APPEAL SUMMARY

Appeal ID: 27629	Project Address: 1616 NW Northrup St
Hearing Date: 3/30/22	Appellant Name: Eli Metcalf
Case No.: B-013	Appellant Phone: 9716782531
Appeal Type: Building	Plans Examiner/Inspector: Steven Freeh
Project Type: commercial	Stories: 3 Occupancy: R-3 Construction Type: V-B
Building/Business Name:	Fire Sprinklers: Yes - NFPA 13D throughout
Appeal Involves: occ Change from to ,other: Change of use from residential duplex to (2) residential transient living units with less than 10 occupants each (Unit A = 5occ, Unit B = 9occ).	
LUR or Permit Application No.: 22-103397-CO	
Plan Submitted Option: pdf [File 1]	Proposed use: Residence –Transient Living (R3)

GROUND FLOOR PLAN (UNIT A)
SCALE: 1/16" = 1'-0"

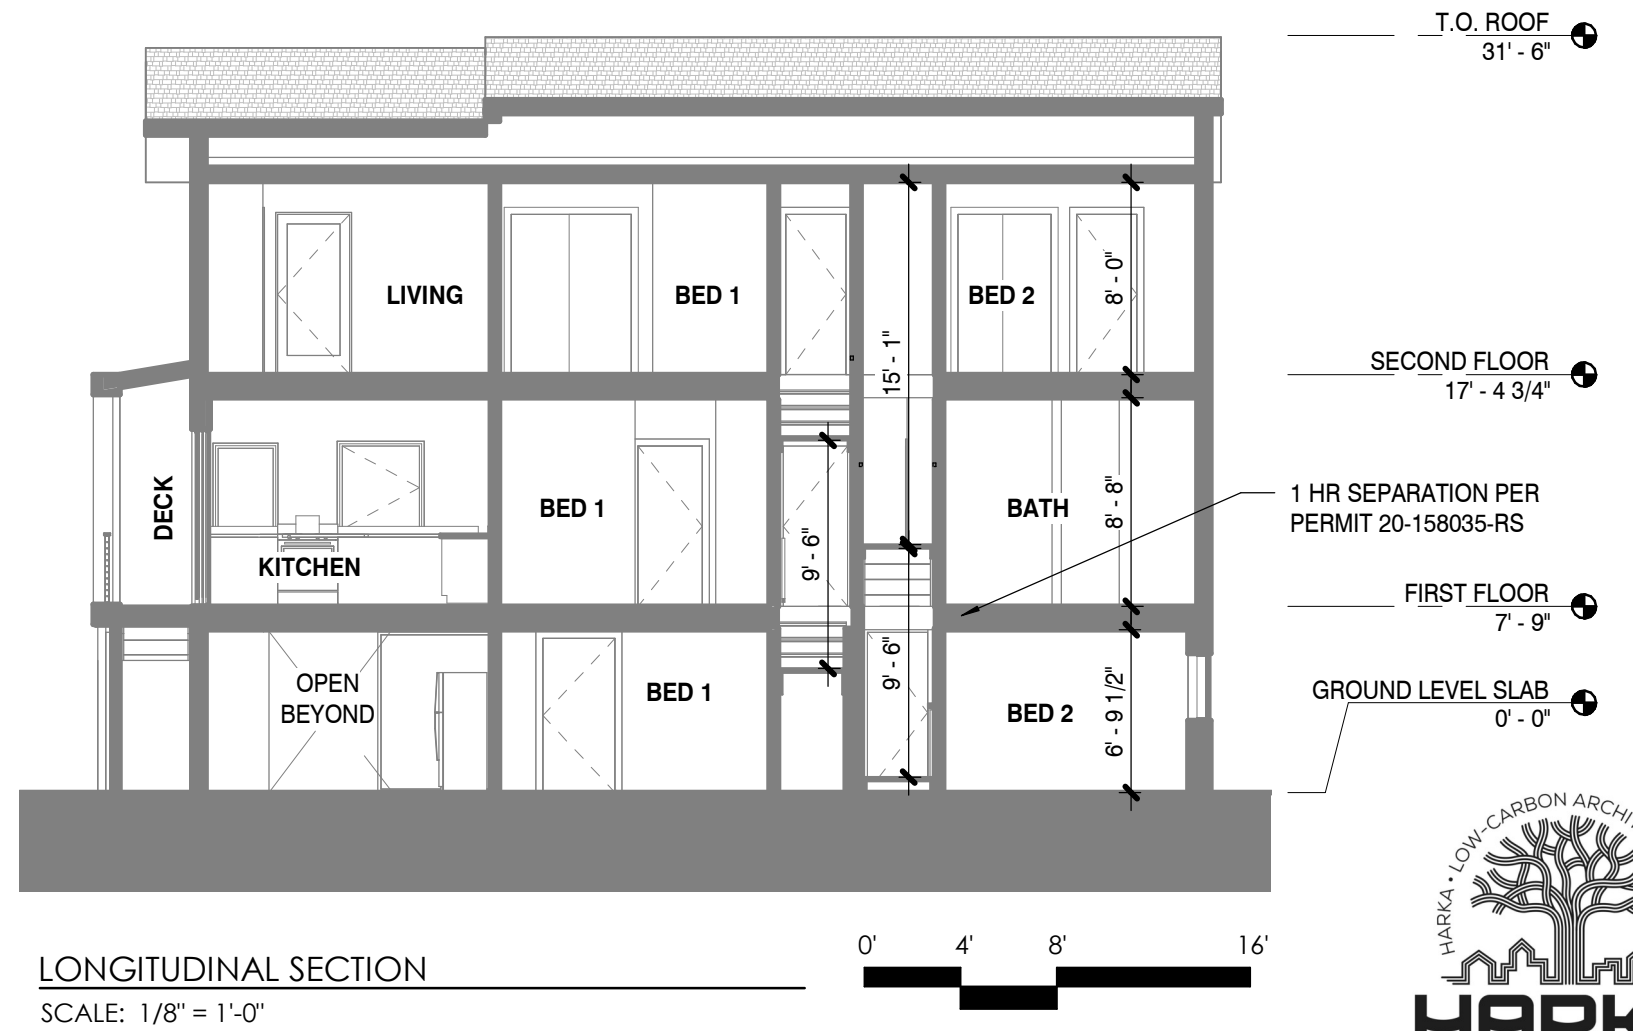
Code Modification or Alternate Requested Requesting lower than 7'-6" ceilings in the basement unit.

Proposed Design We propose a 6'-9.5" ceiling.

Reason for alternative Since a 6'-8" ceiling height is permitted in the Portland code guide for residential basements, we believe that the use of these units matches the intention of the residential ceiling height requirement, rather than the 7'-6" commercial requirement. These are single family dwelling units, intended to be rented to a single group (no more than 5-6 people). The occupancy is R3 and hazard is nearly identical to it's currently R3 use. Excavating the basement slab to add 8.5" represents an unreasonable burden.

4. Reduction in minimum required headroom in basement unit from 7 feet 6 inches to 6' 9.5 inches: Hold for additional information.

SOUTH ELEVATION
SCALE: 1/8" = 1'-0"

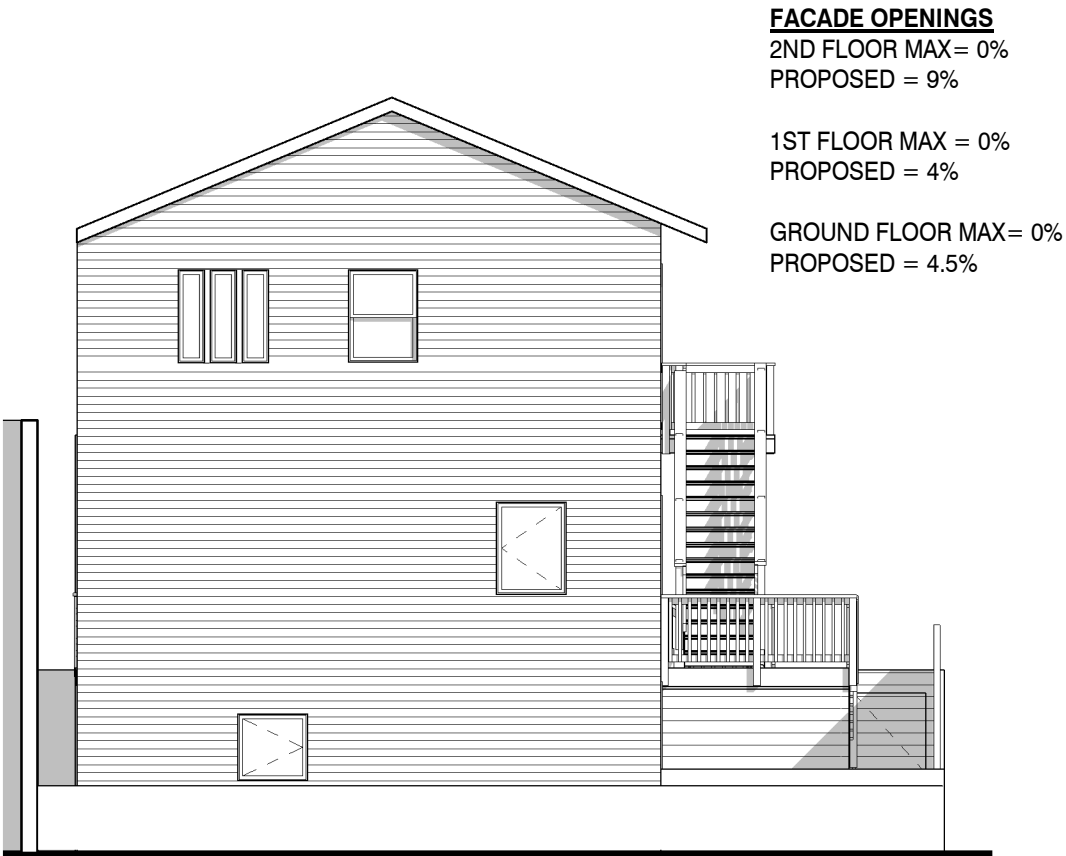
Code Section	Table 602
Requires	Exterior walls less than 5' from the property line shall have a 1-hour rated assembly.
Code Modification or Alternate Requested	We are asking to allow the south wall to remain as-is without a listed 1 hr rated assembly.
Proposed Design	We are proposing to convert this property from a duplex (R3) to a residential transient living R3 with 10 or fewer occupants. We are proposing to install a new NFPA 13D fire sprinklers system throughout the home. The system will be installed on all three levels (ground floor, first story, second story). The south wall will remain as is: 2x4 construction with a single layer of gypsum wallboard on the interior and sheathing and fiber vinyl siding over wood siding on the exterior.
Reason for alternative	The building was built per residential code allowing exterior walls to be unrated and have a fire separation distance of 3' or more. These are single family dwelling units, intended to be rented to a single group (no more than 5-6 people). The occupancy is R3 and the hazard is nearly identical to it's currently R3 use. Therefore, we feel that we are exceeding the intention of the code by adding a sprinkler system. To reconstruct the walls to be 1 hr rated would pose an undue and unnecessary burden.

Code Modification or Alternate Requested	On the south wall, we are requesting 4.5% unprotected openings in the ground floor, 4% unprotected openings in the first story, and 9% unprotected openings in the second story.
---	--

Reason for alternative	Although the proposed NFPA 13D sprinklers do not qualify as "Sprinklered" protection in Table 705.8, they still provide a strong degree of safety, and are more appropriate in a residential setting. Given that the area of unprotected openings is low, and that these are dwelling units with residential use, allowing the openings to remain as-is with the new proposed NFPA 13D sprinkler system sufficiently protects the life and safety of the users. This is not a commercially scaled building and should not have to adhere to the stricter standards of the commercial code. 3 out of 4 windows on the south facade are the only means of egress windows for bedrooms on each floor. Infilling the windows or replacing them with "Protected" openings would pose an undue and unnecessary burden, reduce south facing light, reduce air ventilation to the users, and eliminate means of egress.

1. Existing non-fire rated South wall to remain: Granted as proposed with 13D sprinkler system on separate permit through the Fire Marshal's office.

2. Change of use with existing South wall non-fire protected openings to remain: Granted as proposed with 13D sprinkler system on separate permit through the Fire Marshal's office.

EAST ELEVATION
SCALE: 1/8" = 1'-0"

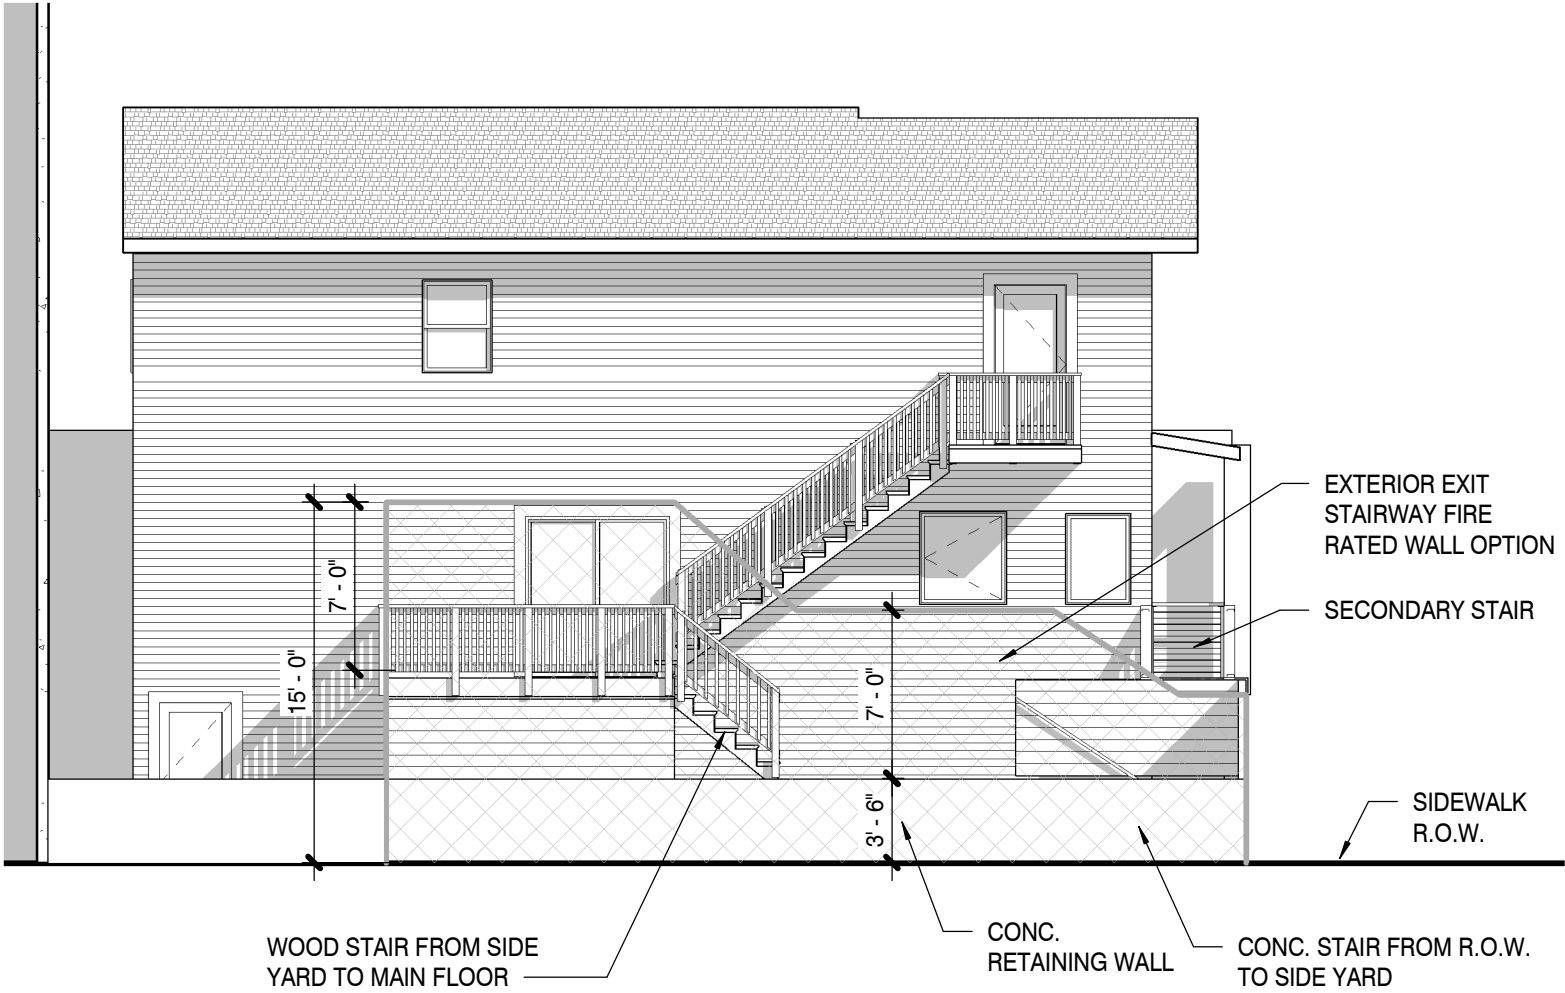
Code Modification or Alternate Requested	Requesting less than 5-foot separation along stair from main floor to side yard and side yard to public right of way.
---	---

Proposed Design	We propose to maintain the existing 3-foot separation along the exterior wood stair from grade to main floor deck, and no separation along the concrete stair from grade to the public right of way.
------------------------	--

Reason for alternative	The adjacent lot is currently a vacant parking lot. If developed, the building would be required to have a fire rating along the property line. Thus, the existing and future developments pose less danger to the egress stair and exiting occupants. The concrete stair to the public right of way is non-combustible and does not pose a danger to the adjacent property. These are single family dwelling units, intended to be rented to a single group (no more than 5-6 people). The occupancy is R3 and hazard is nearly identical to it's currently R3 use. The residential code specifies that a 3' separation is sufficient for residential use. The wooden stairway to the main floor from the side yard is located 3' from the property line. Additionally, a second egress stair is located at the north facade and exists more than 5' from the property line. We feel that the cost to add a 7' one hour wall on top of the existing 3'6" retaining wall along the east property line would outweigh the minimal benefit gain.

3. Reduction in minimum fire separation distance of exterior exit stair from 5 feet to 3 feet: Granted provided the 13D sprinkler system is monitored and provided horn strobes are installed per Fire Marshal on separate permit.
